**ADDENDUM NUMBER 02**

**Project No. 22009 / 23007**  
**Sandusky County EMS**  
**Life Squad Station 14 / SCEMS Administrative Offices & Life Squad Station 18**

This Addendum supplements and amends the original Drawings and Specifications dated **October 24, 2024**, and shall be taken into account in preparing bids and becomes a part of the contract documents. Note: this addendum information is issued to bidders of record. It is the prime contractor's responsibility to forward this Addendum information to all affected suppliers and sub/contractors and make adjustments relative to the proposal. Bidders should acknowledge receipt of Addendum on Page BF-1 of the Bid Form, or the last page of this Addendum.

**13 GYM**  
A10.1 1/2" = 1'-0"

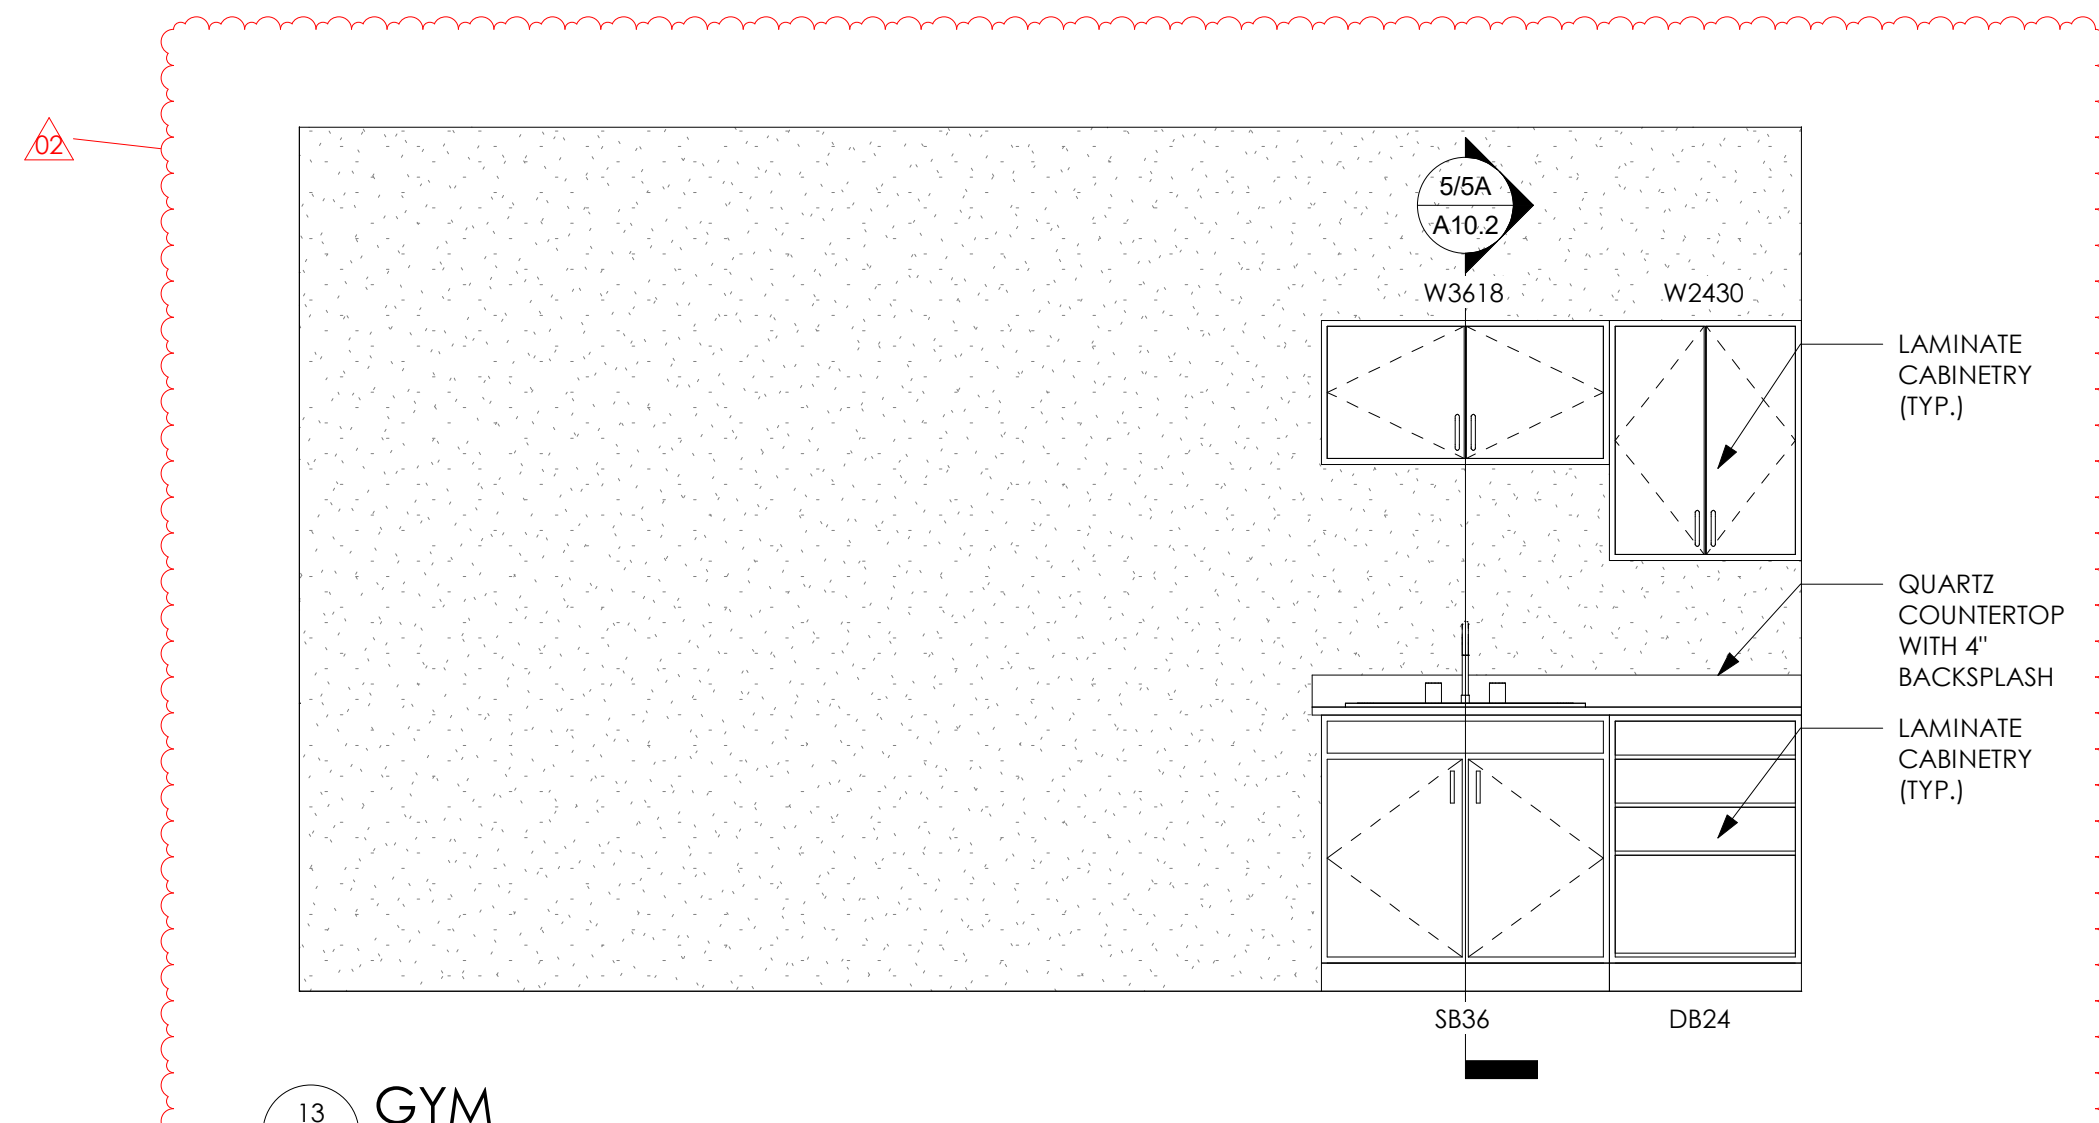
3. **A5.1**
  - a. **Elevation 2/A5.1**
    - i. Added keynote material tag "B2" for upper portion of brick veneer wall
4. **A9.0 (REISSUED)**
  - a. **Door Schedule: Doors 116A / 116B**
    - i. Door material changed to Insulated Steel.
    - ii. Door Frame material changed to Galvanized Steel.
  - b. **Door & Frame Elevations: Revised elevation 4 for OHD.**
5. **A10.1 (REISSUED)**
  - a. **Elevations 10 & 13 added.**

**A: Interior elevations 10 & 13 have been added to sheet A10.1 for life squad 14.**

2 PROPOSED SCEMS ADMIN OFFICE & LIFE SQUAD 18 SITE PLAN  
A1.0 1" = 30'

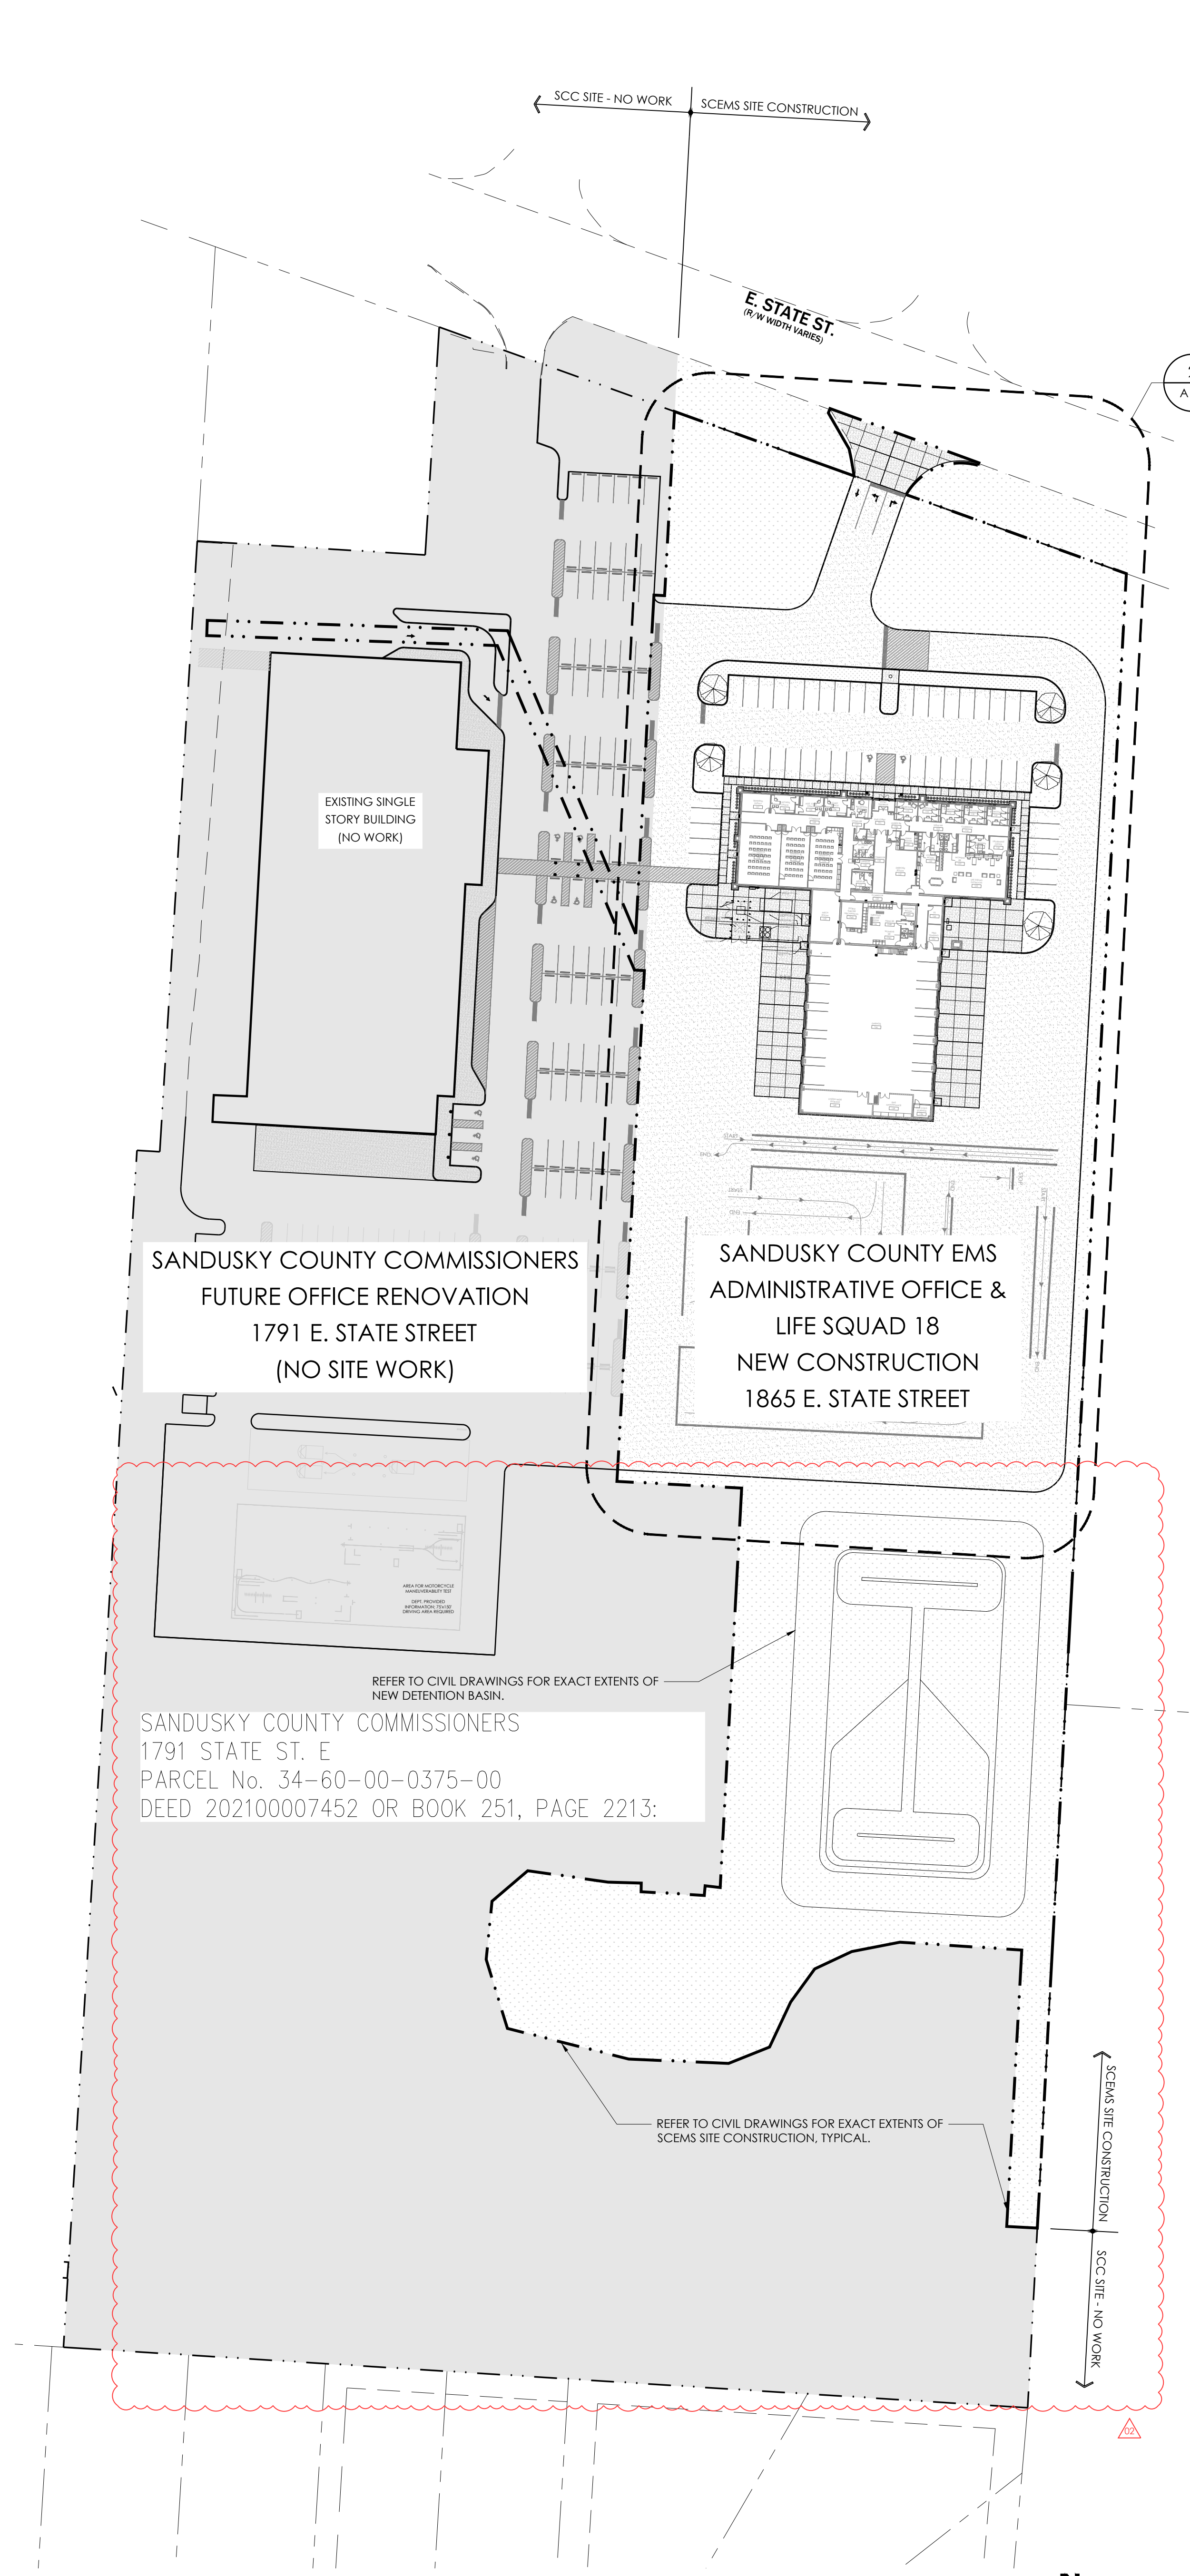
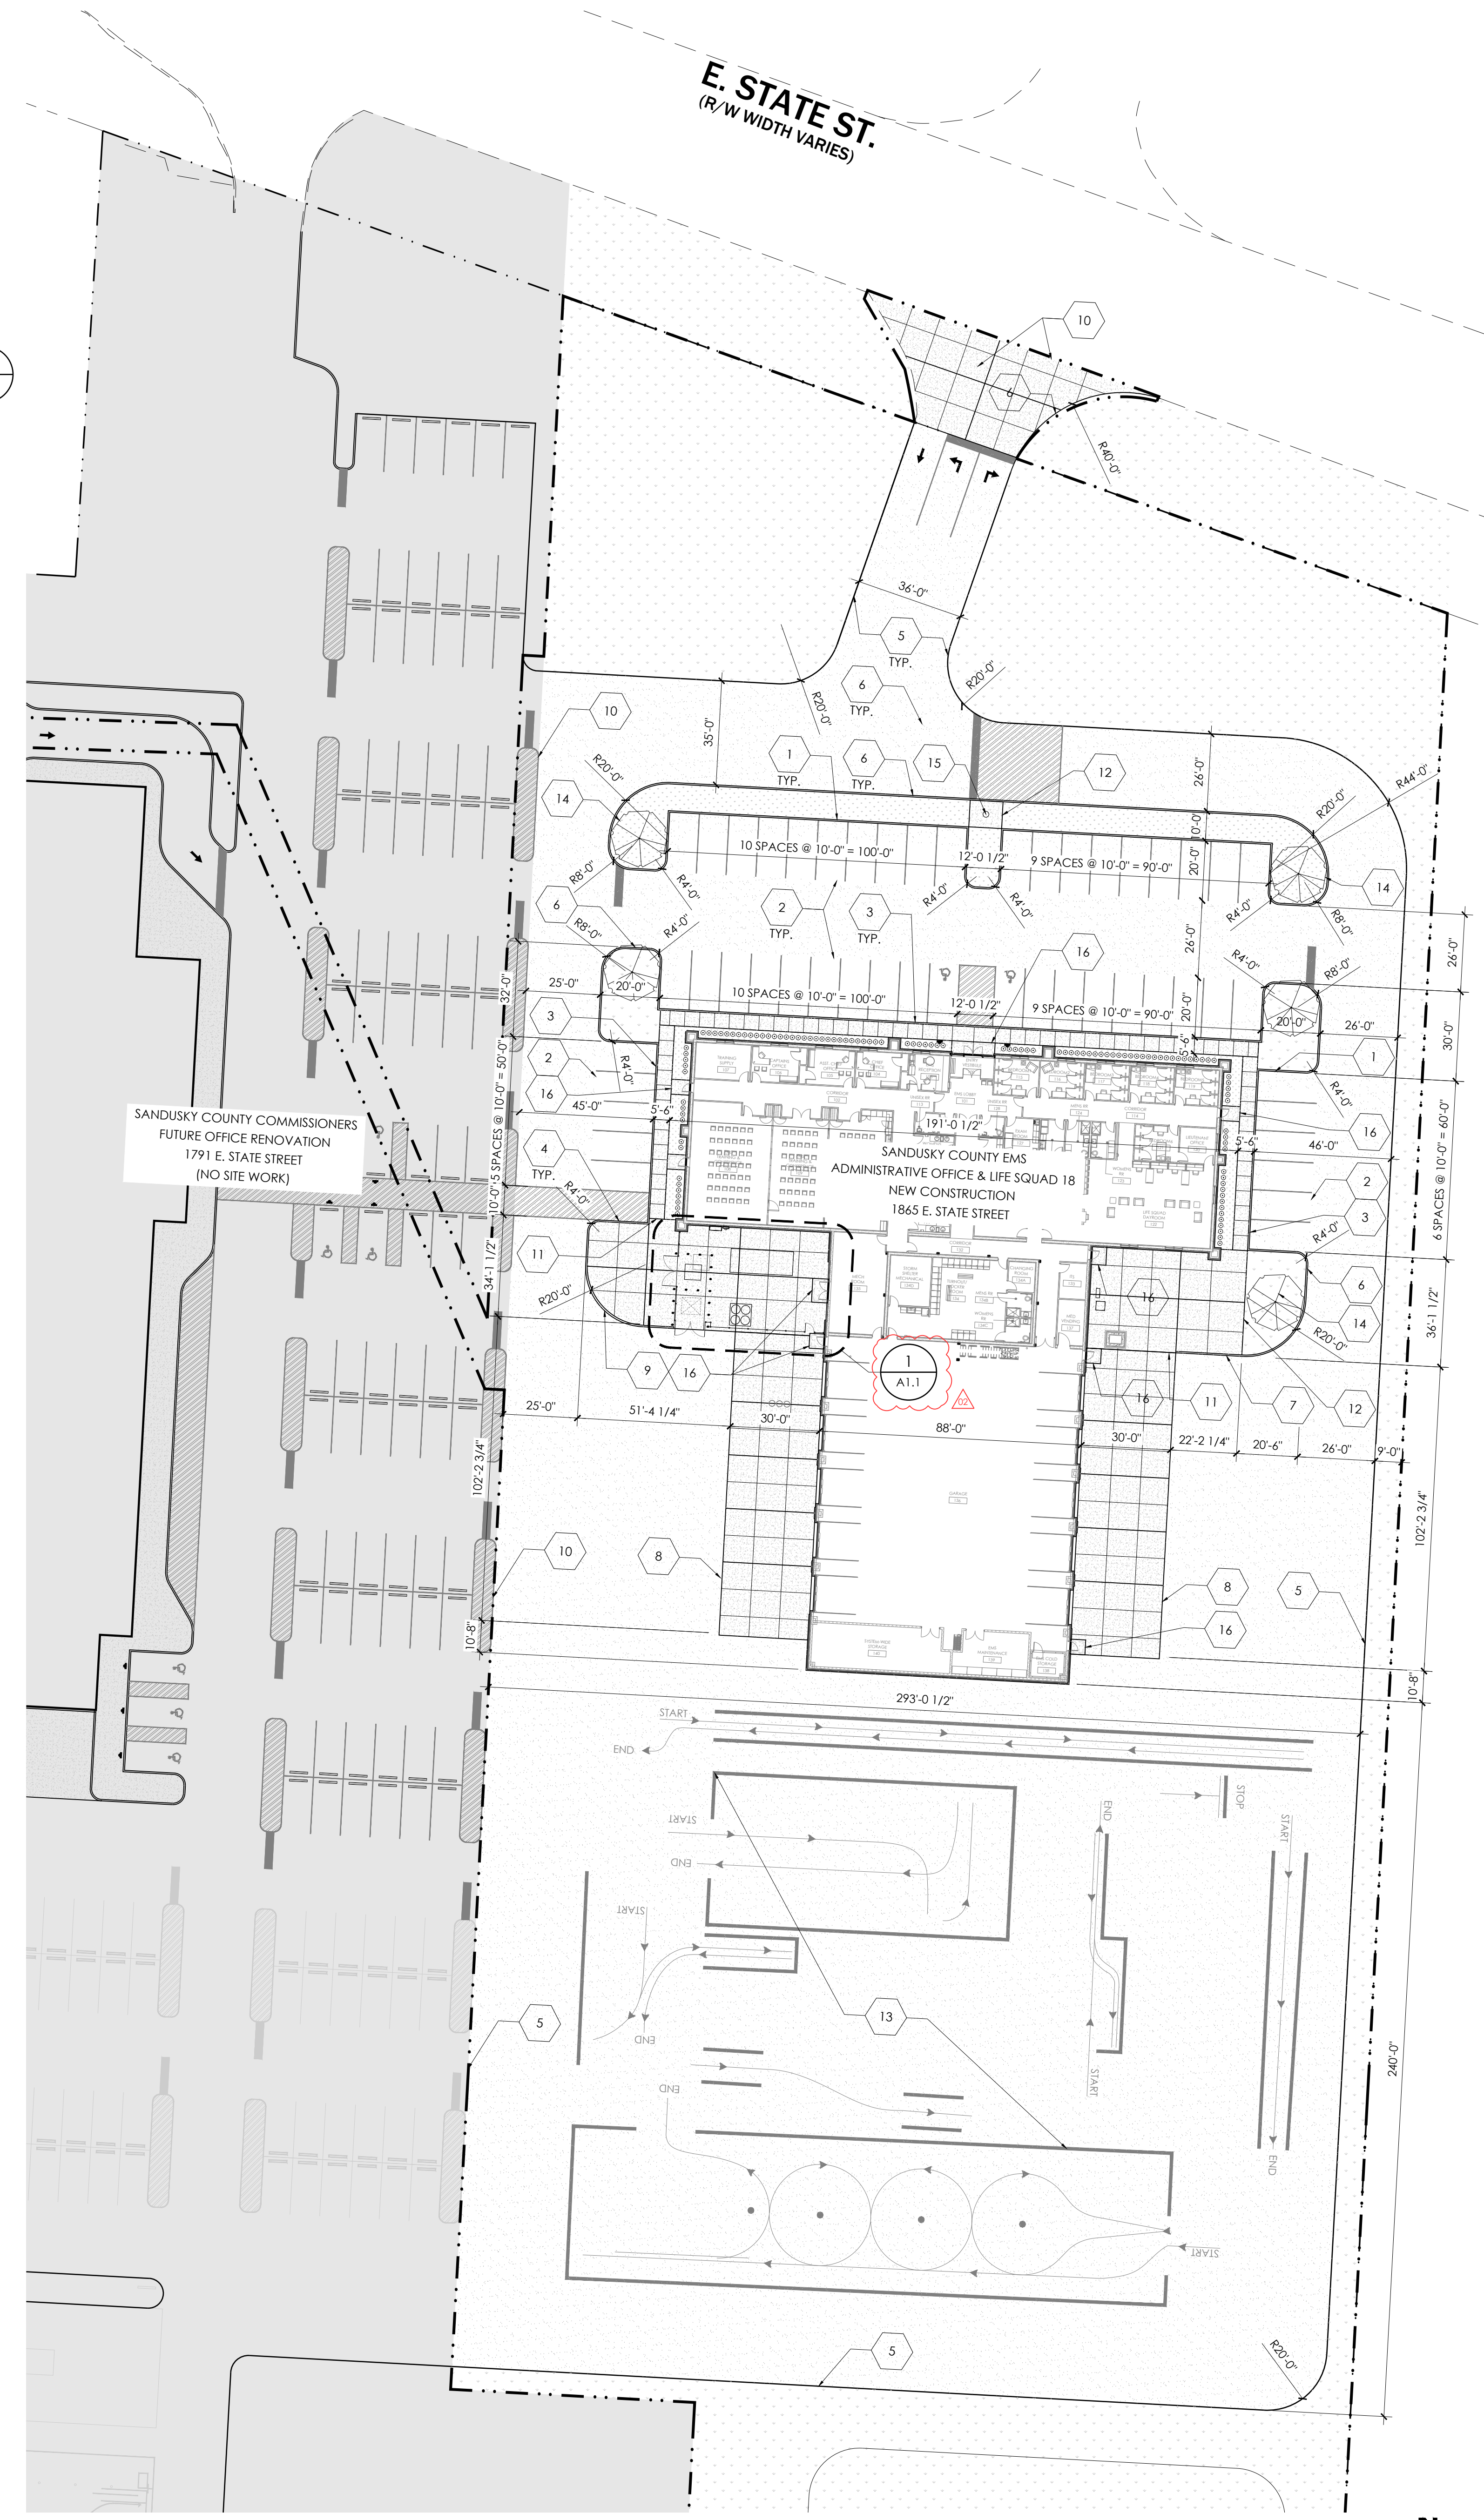
1. **A1.0 (REISSUED)**
  - a. 1/A1.0: added storm detention basin and note to site plan, revised area of work boundary to match civil drawings.
  - b. 2/A1.0: revised mechanical yard fencing / bollard layout, refer to detail 1/A1.1
